North Dakota Department of Transportation

ADDENDUM 2 – JOB 43

TO: All prospective bidders on project SIM-8-029(136)053, Job No. 43 scheduled for the November 14, 2014 opening.

ATR Details
 RP 55.5
 I-29 southbound

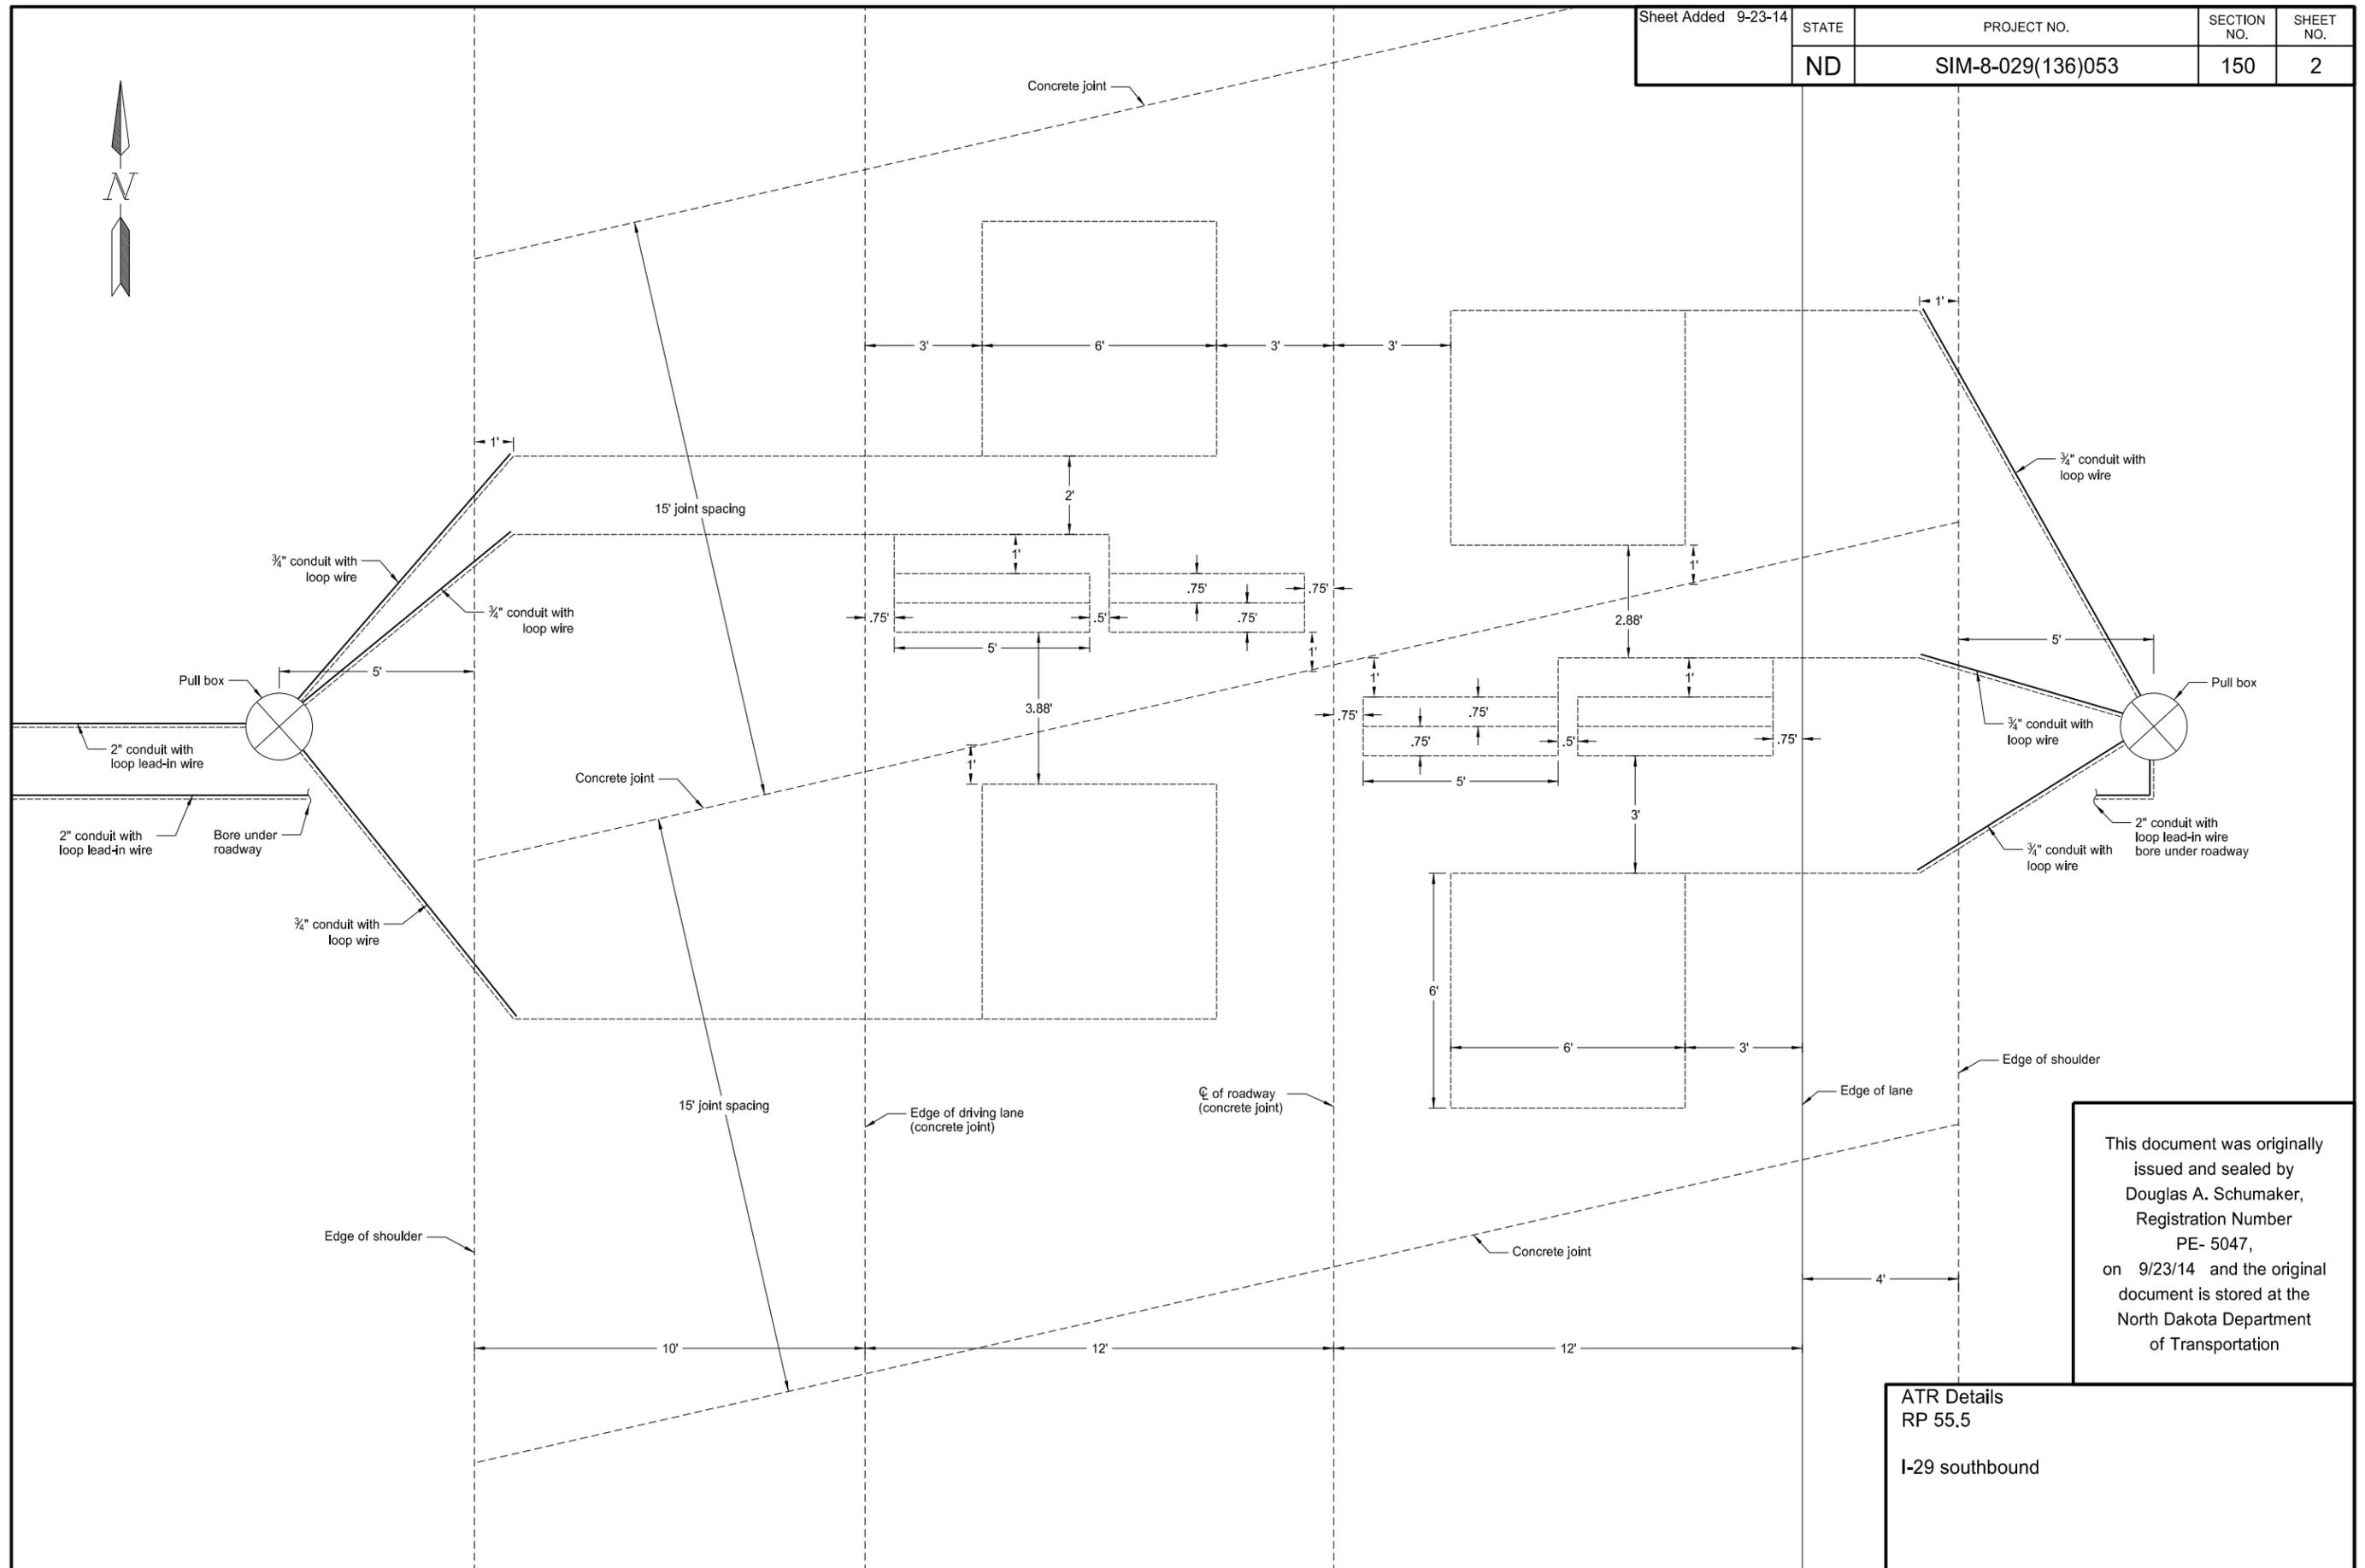
Sheet 150-1 to 150-4:

New ATR site details.
